INFORMATION REQUEST
(Given under Section 12 of the Development Assessment Rules)

Application Number: CA 2025_5732/1
Approval Sought: Development Permit

- A Combined Development for: -
- A. Material Change of Use For: -
1. Undefined Use for Workers' Accommodation (Impact Assessment);
 2. Tourist Park (Impact Assessment); and
 3. A Caretaker's Accommodation (Code Assessment);
- And
- B. Operational Work for an Advertising Device (Not Being a Third Party Advertising Device) (Impact Assessment);
- With the Development to be undertaken in two Stages.

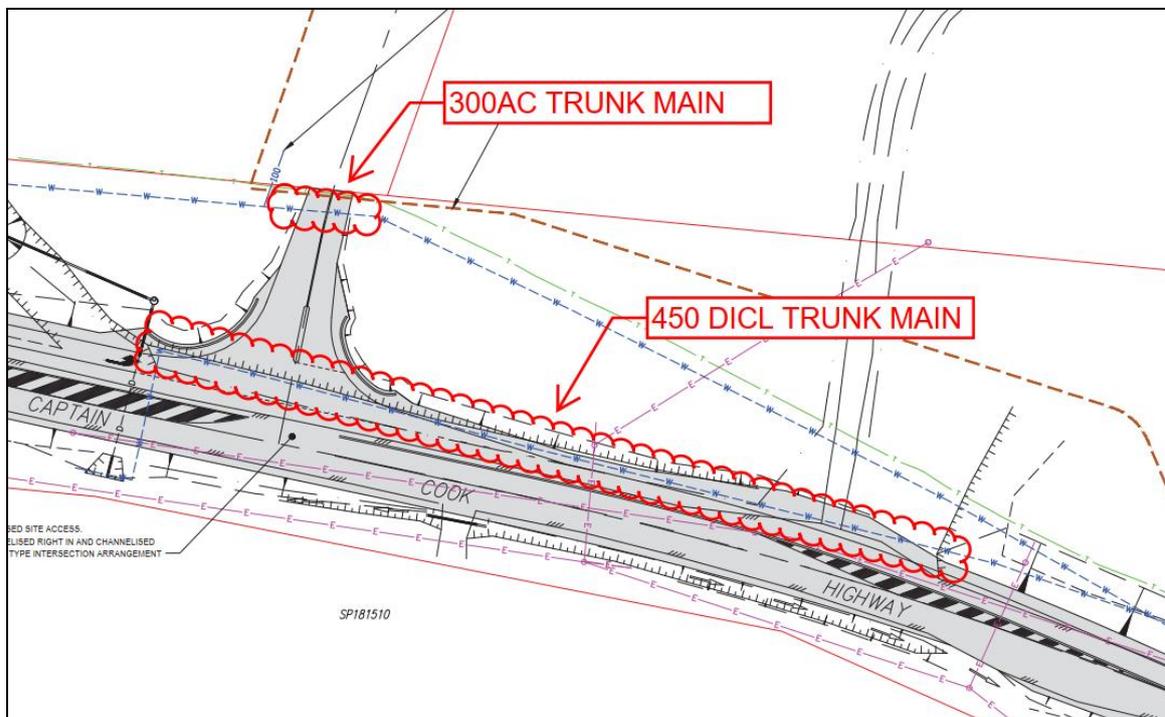
The proposed alignment plan appears to nominate new main service connections beneath mounded landscaping in the adjacent road area.

- a. A concept level sewerage connection plan showing the alignment of the sewer from the site to the connection point with Council's system, specifying whether it will be pressure or a gravity system and indicate the pipe size.

It is recommended that the applicant arrange a meeting with Council Officers to discuss and confirm proposed alignment and connection point options before submitting the above details.

5. Please clarify the private pump station will be located on the applicant's land and will subject to the achievement of a separate ERA.
